2018 - 2019 Cadillac ATS-V - CTS-V: Service Bulletin: #20-NA-054: Rear View Camera Guidance Lines Dim After Radio Replacement or Programming

#20-NA-054: Rear View Camera Guidance Lines Dim After Radio Replacement or Programming - (Mar 3, 2020)

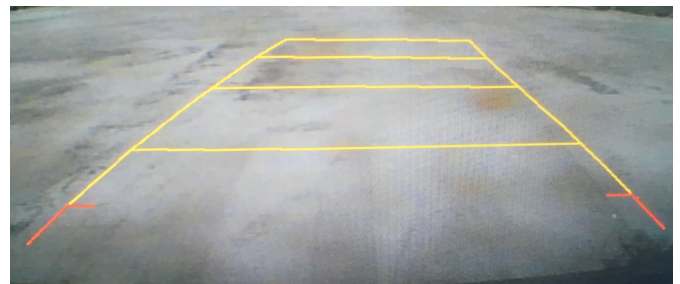
Some customers, after having radio replacement or radio reprogramming, may report that the Rear-View Camera (RVC) guidance lines are not as bold

as previously viewed, that they are faint, see-through, thinner, dim, or translucent; and they used to be more visible. A comparison between similar vehicle models may, or may not, show a difference in rear view camera guidance line appearance.

This may be caused by installing calibration files released in mid-2018 during radio replacement or reprogramming of the radio. The change to increase translucency was done to prevent the lines from

obstructing objects in the field-of-view.

Do not attempt repairs. The thinner, lighter appearance of RVC guidance lines is operating to design intent.
